ECE/TRANS/WP.15/AC.2/2008/7
31 October 2007

PROPOSALS FOR AMENDMENTS TO THE REGULATIONS ANNEXED TO ADN**

Alternative constructions (tank vessels)

Transmitted by the Central Commission for the Navigation of the Rhine (CCNR)***

Figure 2: Definition vertical striking locations

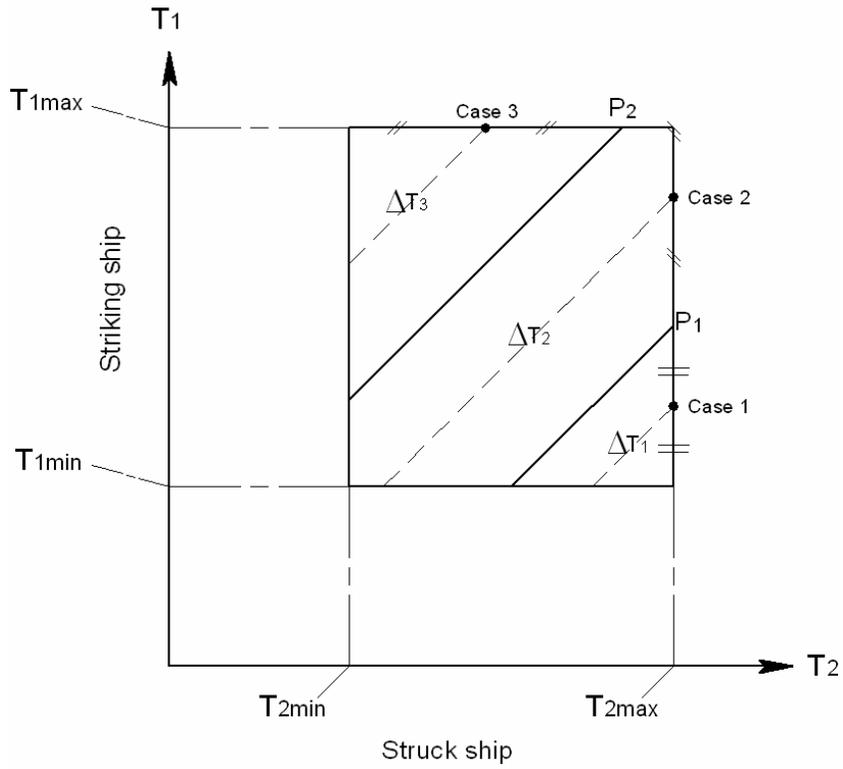
The striking locations in the vertical direction are defined by the draught differences of striking and struck vessels. Based on the ballast and design draughts of both striking and struck vessels, the collision locations in the vertical direction are defined in the following way (Figure 2):

T_{1max} is the design draught of the striking vessel and T_{1min} is the ballast draught of the striking vessel, while T_{2max} and T_{2min} are the design and ballast draughts of the struck vessel respectively. The area between $T1=T_{1min}$, $T1=T_{1max}$ and $T2=T_{2min}$, $T2=T_{2max}$ is a measure for all collision possibilities. In this example there are 3 vertical collision locations which are represented by three areas ΔT_1 , ΔT_2 , ΔT_3 (Figure 2).

The point P_1 is the case where the lower edge of the vertical part of the push barge bow or the V-shaped bow, strikes at deck level (see section 9.3.4.4.6. for bow shapes). The triangular area in Figure 2, below the P_1 diagonal represents the collision case 'collision above deck'.

The point P_2 is the case where the upper part of the push barge bow or the V-shaped bow, strikes at the upper edge of the shear strake. The area in Figure 2, between the P_1 diagonal and the P_2 diagonal represents the collision case 'collision at deck'.

The area above the P_2 diagonal represents the collision case 'collision below deck'.

Useful weighting factors are obtained for each collision case by dividing the respective areas by the total area representing all collision cases.

Figure 3: Example vertical collision locations

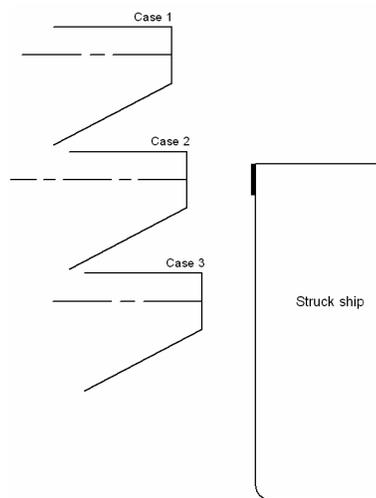
See also Figure 3, which shows these characteristic vertical collision locations.

9.3.4.4.6 *Definition of collision cases*

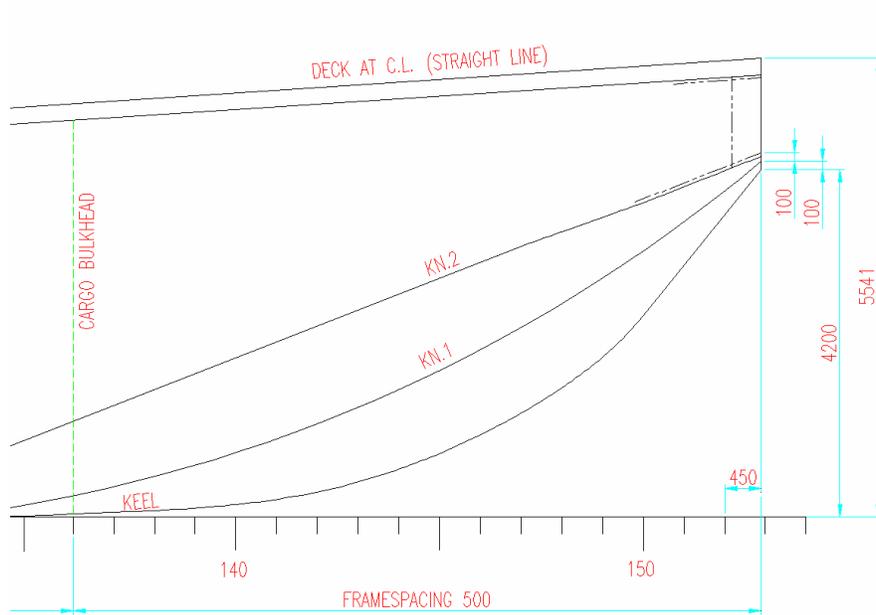
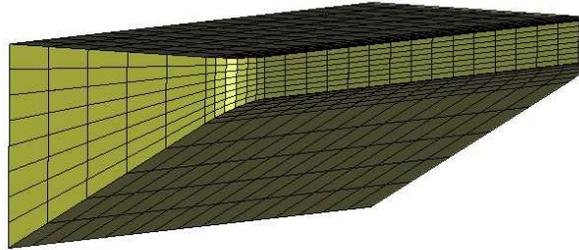
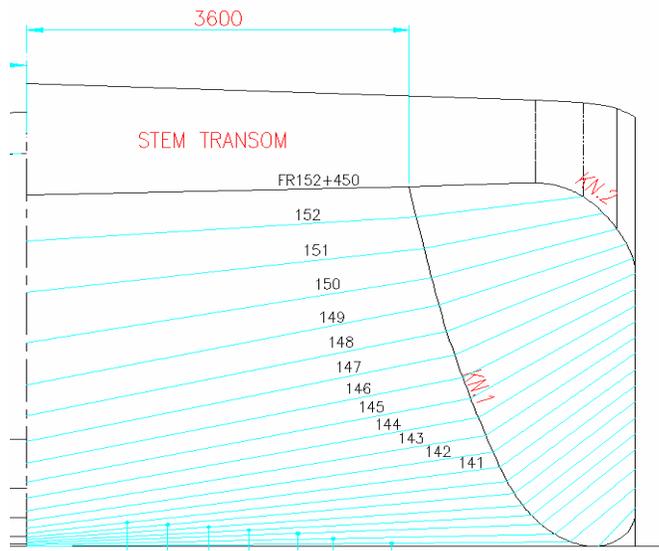
- (a) In case of a collision with the V-shaped bow, the collision angle equals 90° and, in case of the push barge bow, the collision angle equals 55°; and
- (b) The struck vessel has zero speed, while the striking vessel penetrates with a constant speed of 10 m/s.

Pushbarge bow

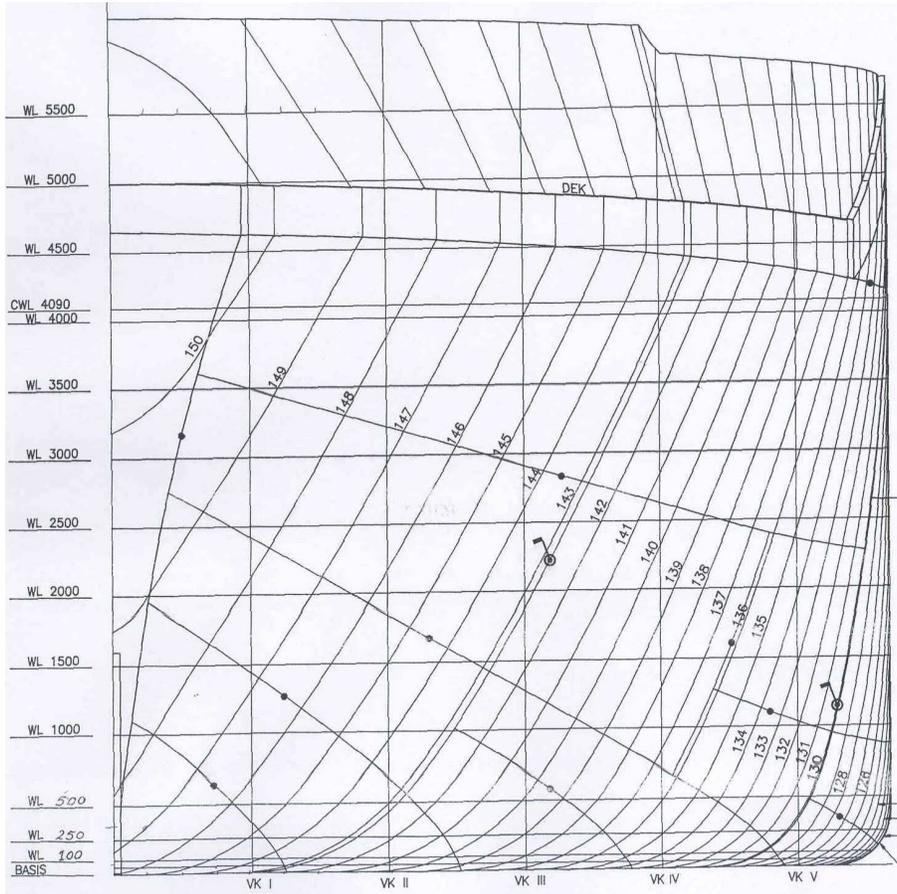
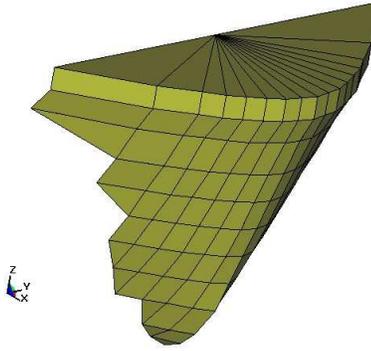
Width: 11,50 m

V-shaped bow

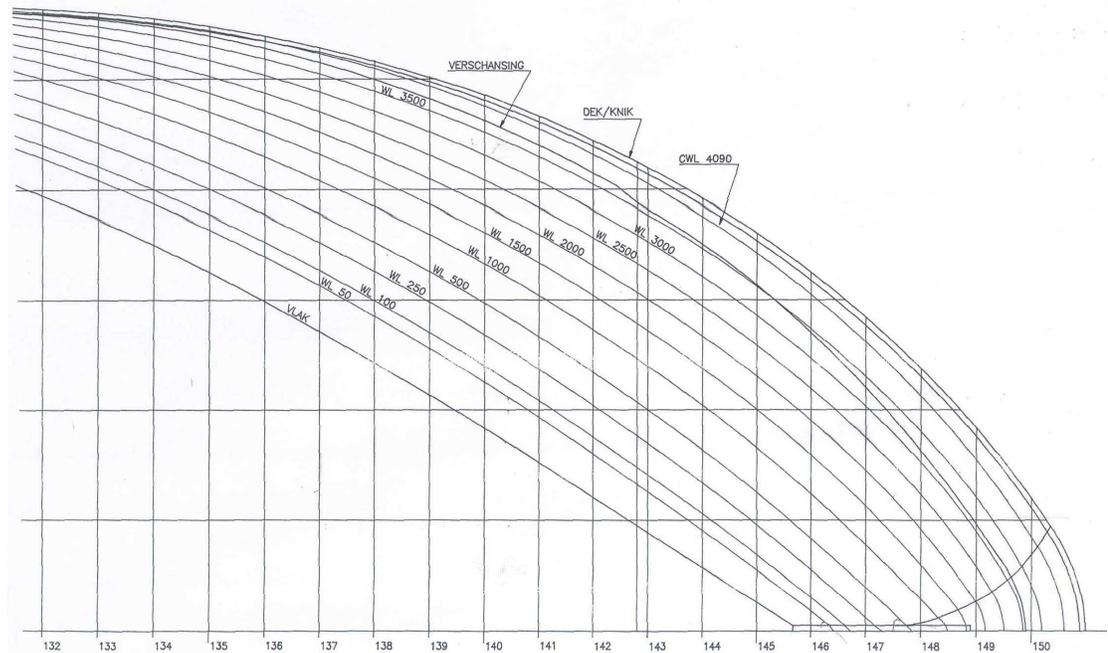
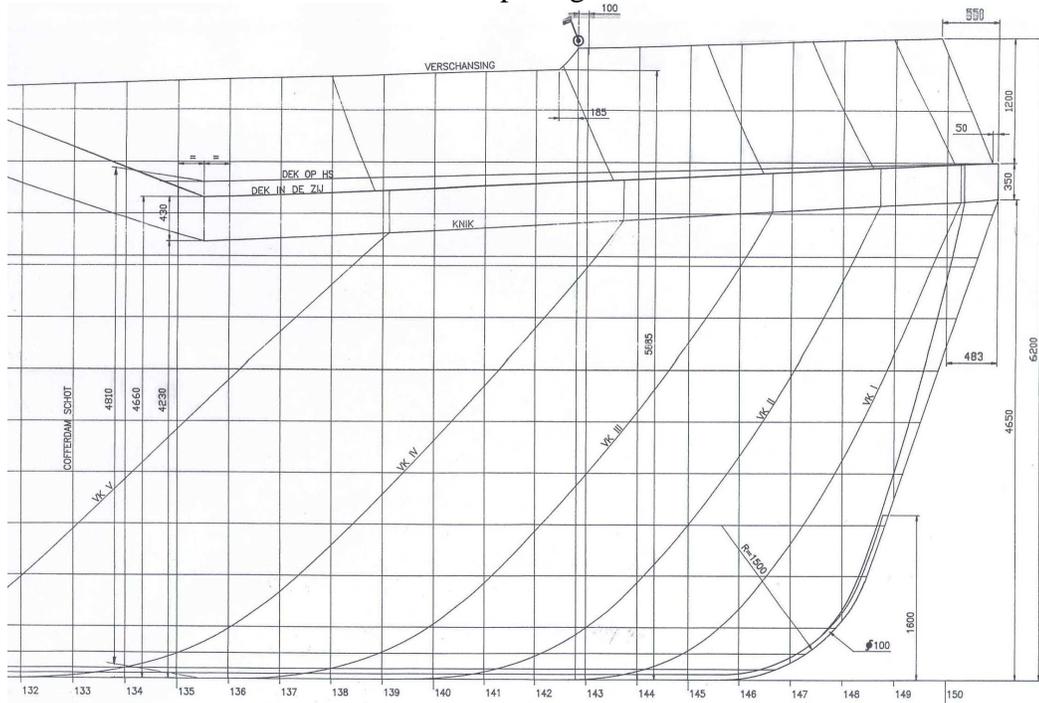
Width: 11,35 m

Framespacing: 500 mm

Buttock spacing: 1000 mm"
